NUMBER D2-14934-3

TITLE WS-133A Maintainability Progress Report (U)

MODEL NO. WS-133A CONTRACT NO. AF04(648)-289

ELECTRICAL CABLE CASE

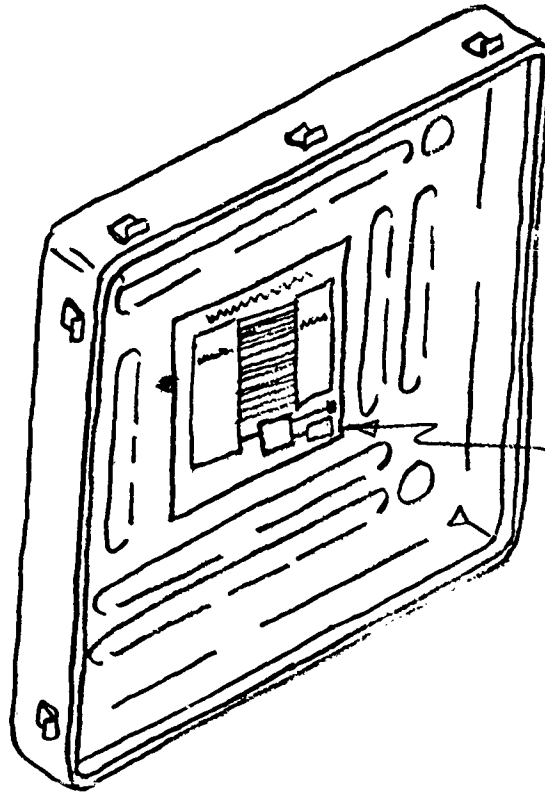
ADD
PLACARD SHOWING
CABLE HOOK-UP
FOR PROGRAMMER
GROUP TEST
SET SELF-TEST
(REF. T.O. 21-SM80A-23)
FIG. 2-25

Provide a cable hook-up placard in the Fault Locator and the Distribution Box suitcases. See attachment B.
